ADDENDUM #1

RFQ # 7549990

**TITLE: CONSTRUCTION OF NEW DOT PORTSMOUTH
MAINTENANCE FACILITY**

S110

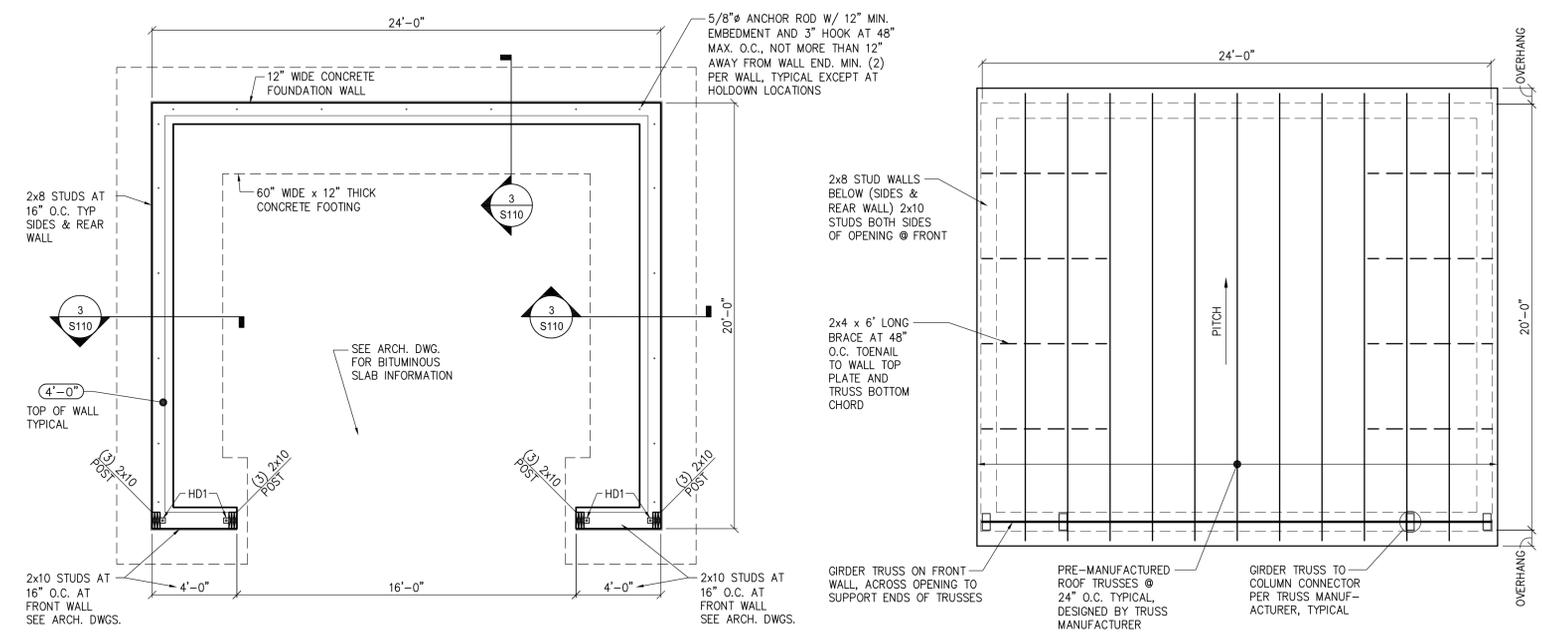
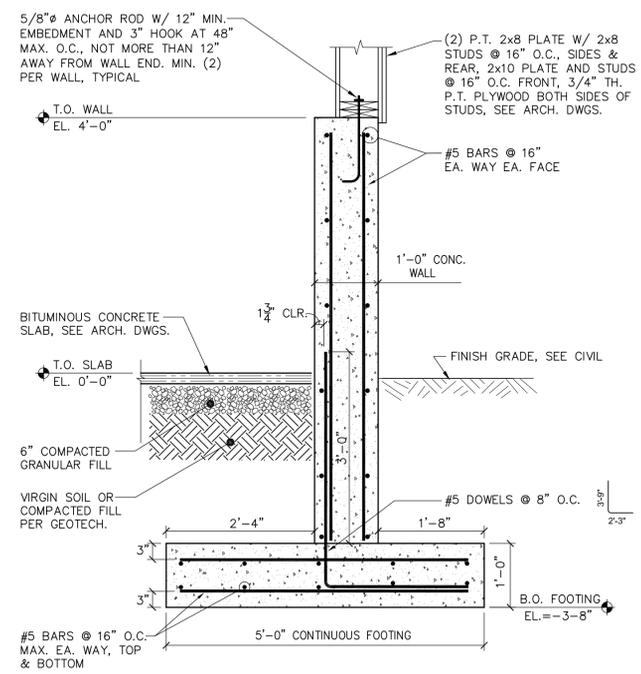
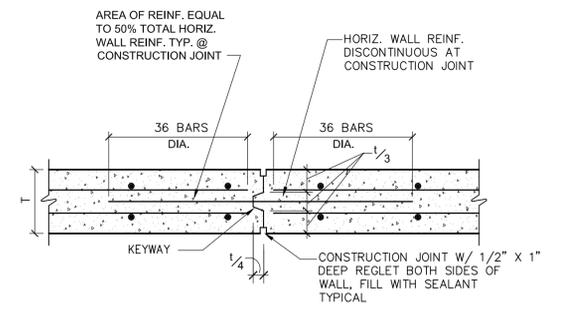
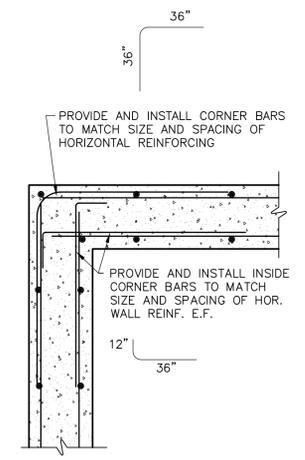
2. Sheet 000 Cover Sheet
 - A. Sheet List
 - 1) Add sheet: 'S110 Cold patch shed foundation plan & details, framing plans, and notes,' dated November 5, 2015

6. Add the following Drawing to the Project Documents
 - A. Structural Drawing:
 - 1) S110 Cold patch shed foundation plan & details, framing plans, and notes
